Amendment C187 Greater Shepparton Planning Scheme

Planning Authority Submission to the Independent Planning Panel

20 September 2016

Figure Five – Proposed Basin B Dimensions

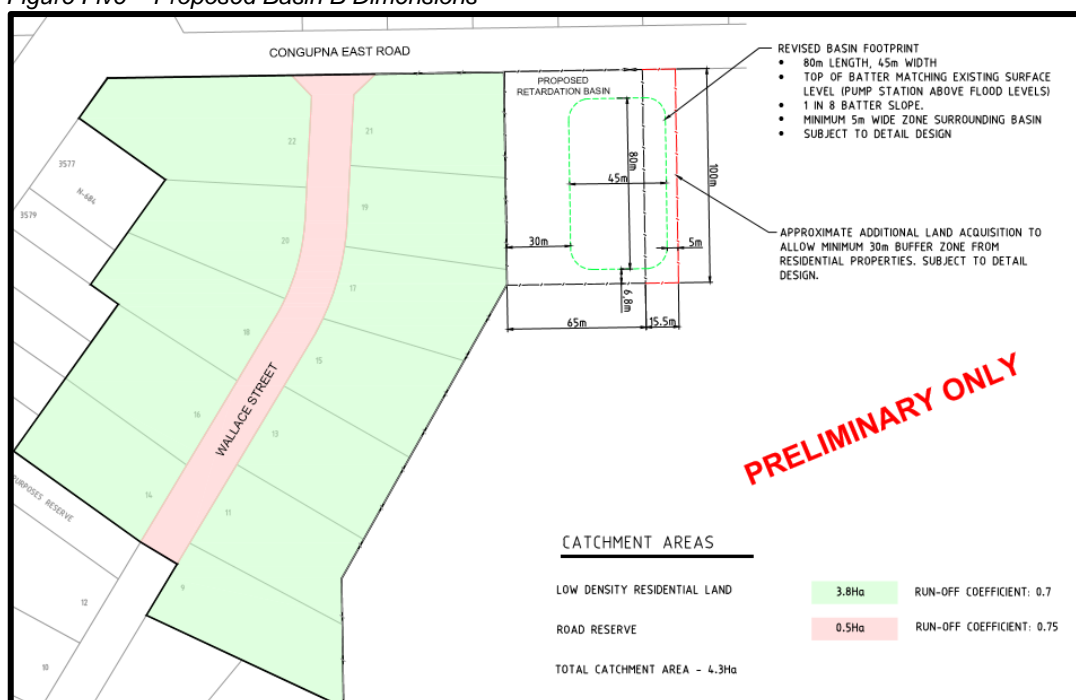
The requirement is the EPA Code of Practice – onsite wastewater management, stating that a retardation basin must have a setback distance of 30m from a property with a septic treatment and grey water effluent treatment.

In order for proposed basin B to comply with the EPA requirement of a 30m buffer, it has been determined that additional land acquisition is required. The amended area of required land acquisition is now 80.5m x 100m (see below *Figure Five – Proposed Basin B Dimensions*).

Council officers met with the land owners of 226 Old Grahamvale Road, Congupna (site of proposed basin B) on 25 July, 2016 to explain the need to increase the extent of the PAO to allow for additional land to be acquired to construct basin B, given the EPA setback requirement.

Proposed Post-Exhibition Changes

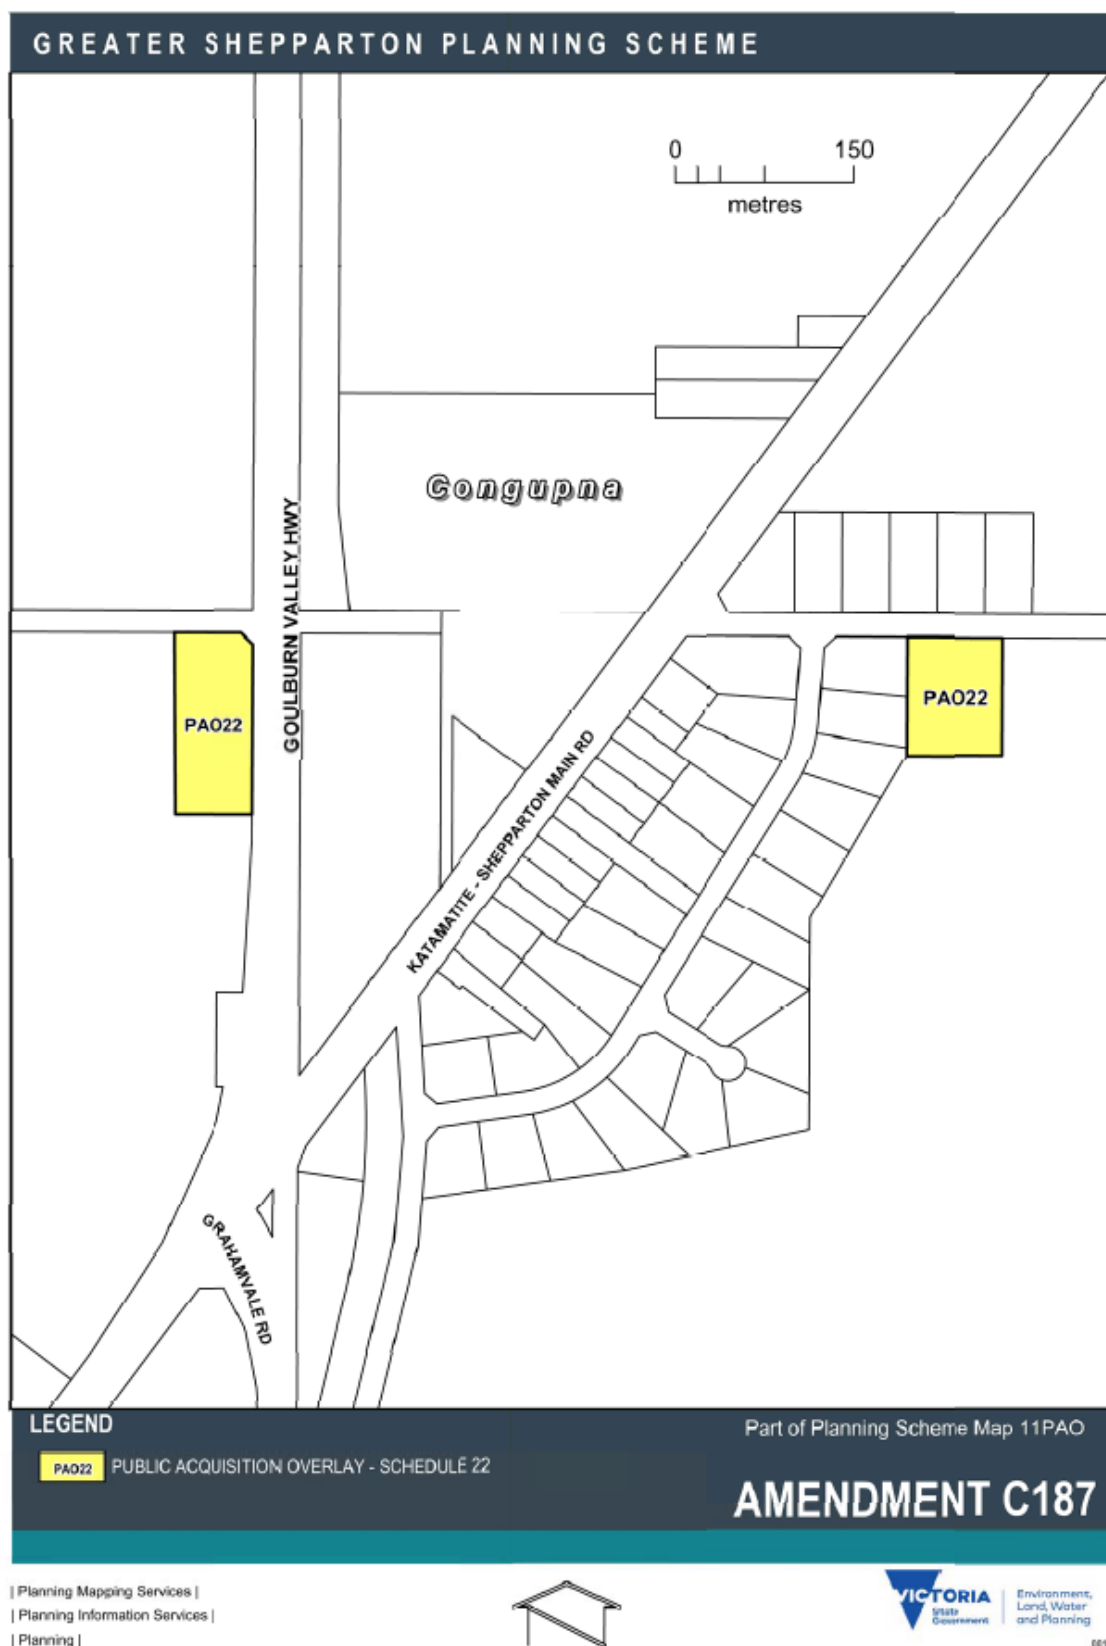
I refer to the letter dated 25 July 2016, providing an explanation for the need to increase the extent of the proposed Public Acquisition Overlay (PAO22) on part of 226 Old Grahamvale Road, Congupna.

I do not object to the post-exhibition change to increase the extent of proposed PAO22 on my land in accordance with the draft detailed designs, provided (Drawing No. R C19-8(2)).
